Donazzan's Dam- Pakenham Quarry

Intermediate Inspection

Client: Holcim (Australia) Pty Ltd

08-Jan-2021

Figure 1 General Plan View of the Donazzan's Dam

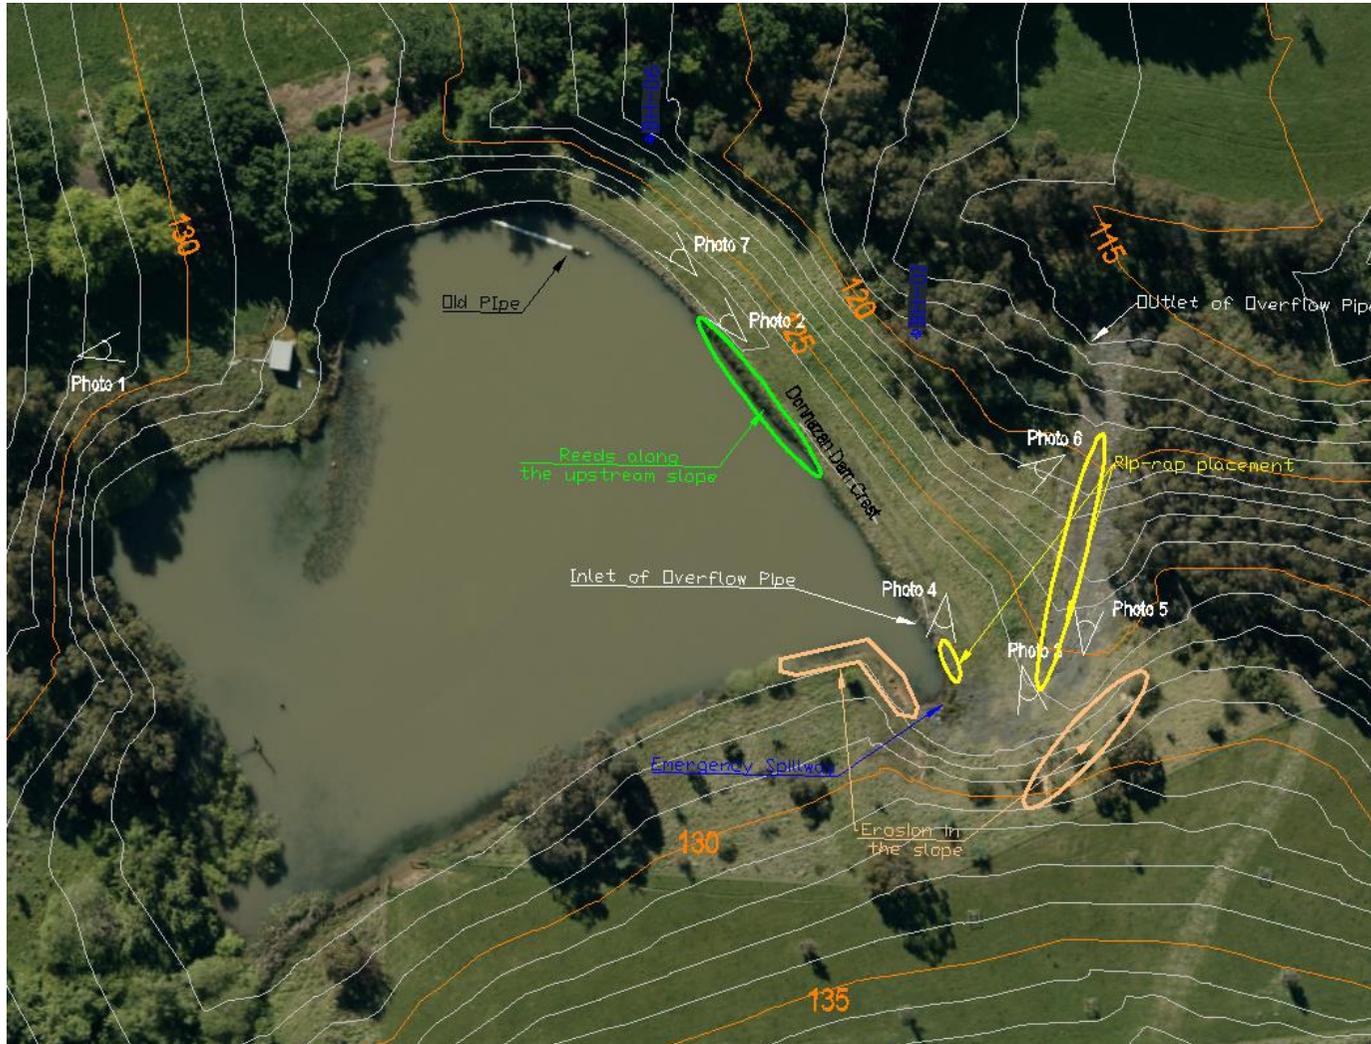
Figure 1 shows the general site layout of Donazzan's Dam and identifies its main components. The site survey shown on the figure was carried out on October 12, 2020. Figure 1 also shows the location of the two monitoring wells (BH-1 and BH-6) measured during the inspection and the location of seven (7) photos taken during the 2020 Inspection. These photos are presented in Appendix A and are compared to photos taken in the 2015 Coffey Intermediate Inspection at the same location.

Figure 2 Fluctuation of the Water level in BH-1 and BH-6 and the reservoir water level

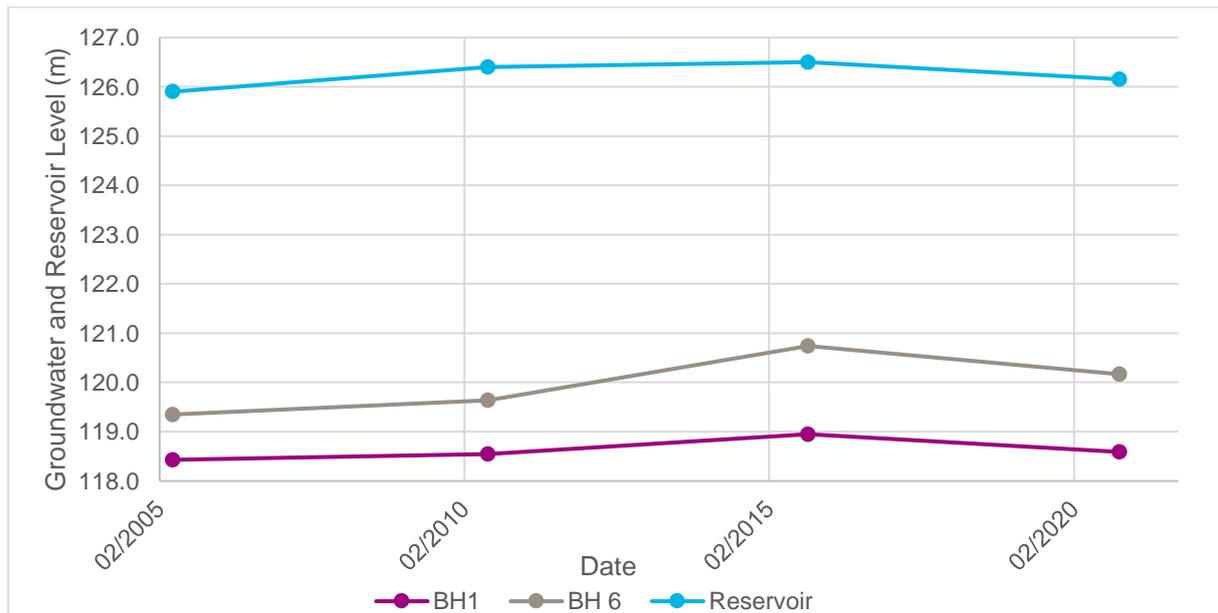
Groundwater levels were measured in the monitoring wells BH-1 and BH-6 located at the toe of the dam. The water level in the reservoir was also assessed based on measurement from the crest of the Dam. The 2020 water levels and historical levels are given in Table 2 and shown in Figure 2.

Monitoring of the water level once every five year does not allow for a lot of interpretation. It can be noted that according to these few measures the water level and reservoir level do not fluctuate a lot and the fluctuation seems to indicate that there is a small response in the downstream piezometer levels and the reservoir level however without rainfall data, this cannot be confirmed..

We recommend, the installation of a survey staff gauge with elevation marks every 0.1 m to help determine more precisely the water level in the reservoir. This water level is a critical input parameter to carry-out stability assessment and would allow to rapidly confirm that the water level is kept below the recommended full supply level.

b) 2020 – Erosion in the Slope Upstream of the Spillway

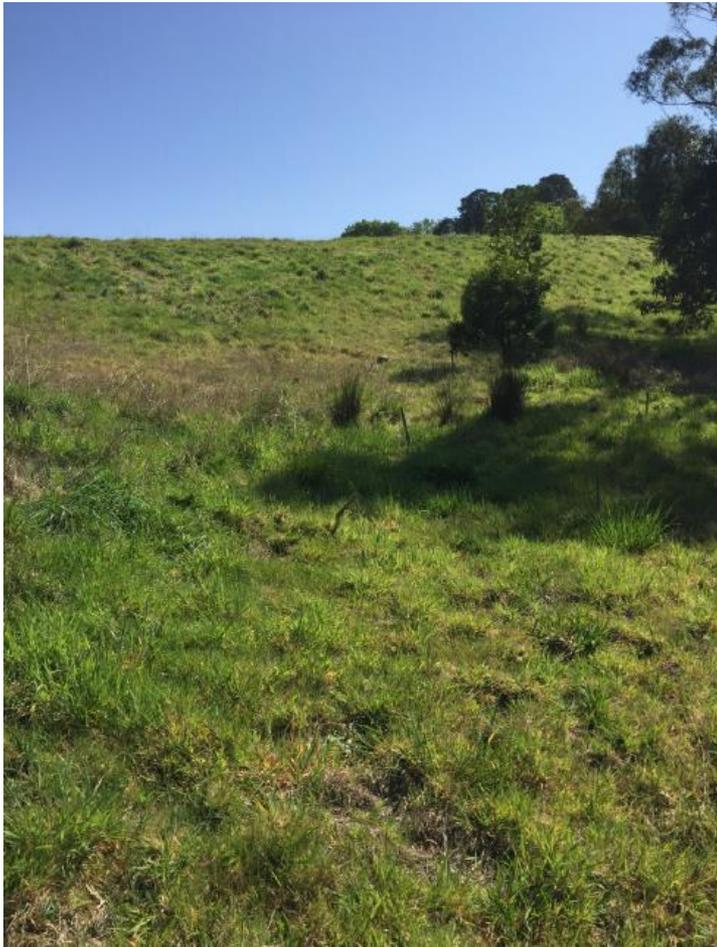
During the AECOM 2020 inspection, erosion of the upstream reservoir banks within the natural hillslopes close to the spillway inlet has been noted. This was also noted in previous inspection. Photo A-6a and A-6b taken in 2015 and 2020 respectively show that erosion has continued in the past year with increase areas of sandy beaches. Photo A-7a and A-7b show that erosion also occurs in the slope upstream of the spillway. Vegetation has been implemented in these areas to help minimise erosion in the slope.

We recommend that the erosion of the spillway channel and side walls be monitored following each spill event and major rainfall events.

PLAN
Scale 1:1000

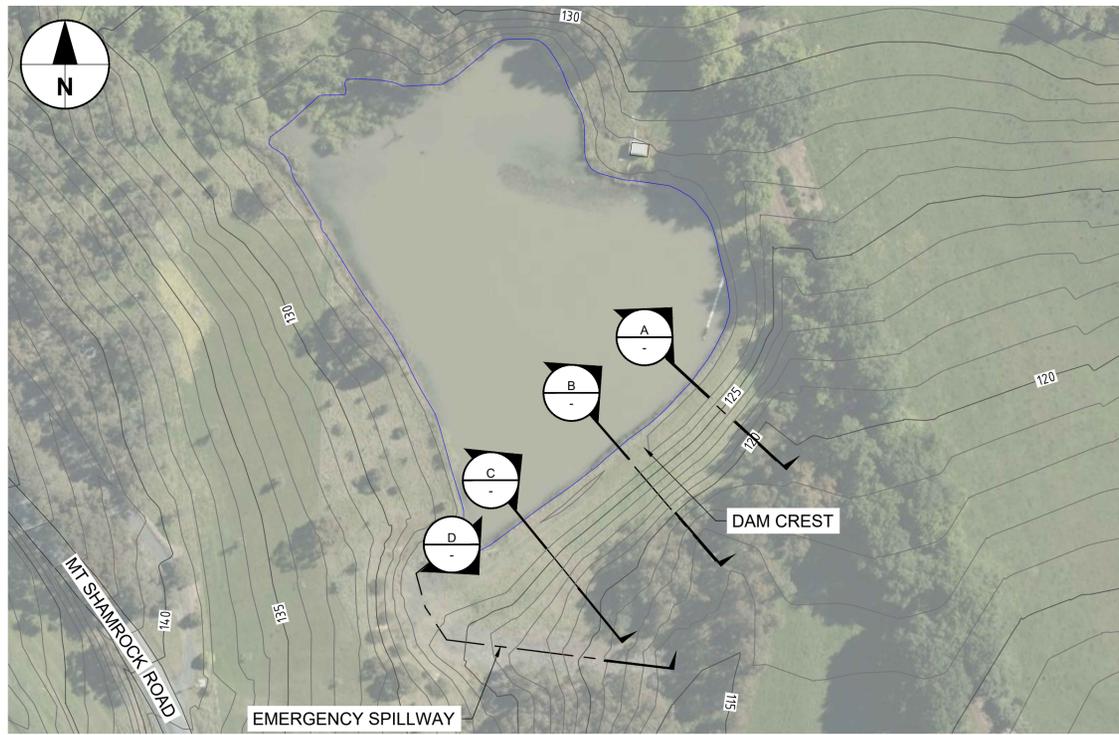
- Dam Cross-section B indicates that the crest is lower than in 2015, and the crest elevation is inconsistent along the crest with the lowest point at about RL 127.0 m. The plan-view also indicates that the western part of the dam is below RL 127.0m. In the initial design, the crest elevation was at RL 127.4 m and was used to determine the FSL (1m below the crest elevation). It would be important to confirm the current elevation of the crest and review the FSL accordingly. We recommend that the crest elevation is built up to be made consistent along the length of the crest at RL 127.4 m to maintain the design freeboard allowance.

- The survey provided should be updated with the following and the drawing in Appendix B updated to include:
 - the location of the existing standpipe piezometers

- Extent of riprap within the spillway
 - The location of inlet and outlet pipes.

C | DAM CROSS-SECTION
SCALE 1:200

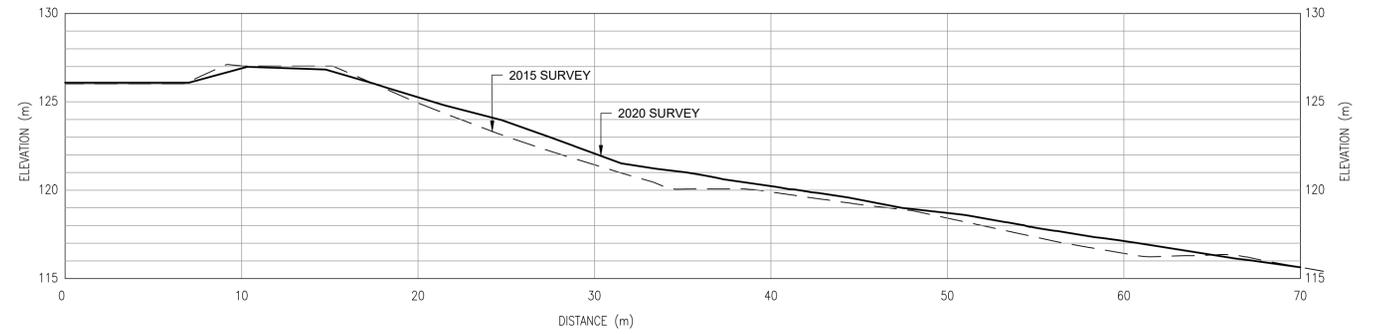
- Dam Cross-section C shows modifications have been made to the crest of the dam with reduction in width to approximately about 5 m wide.
- The longitudinal section of the emergency spillway confirms that it has been backfilled with riprap material in the slope and at the mouth of the spillway.
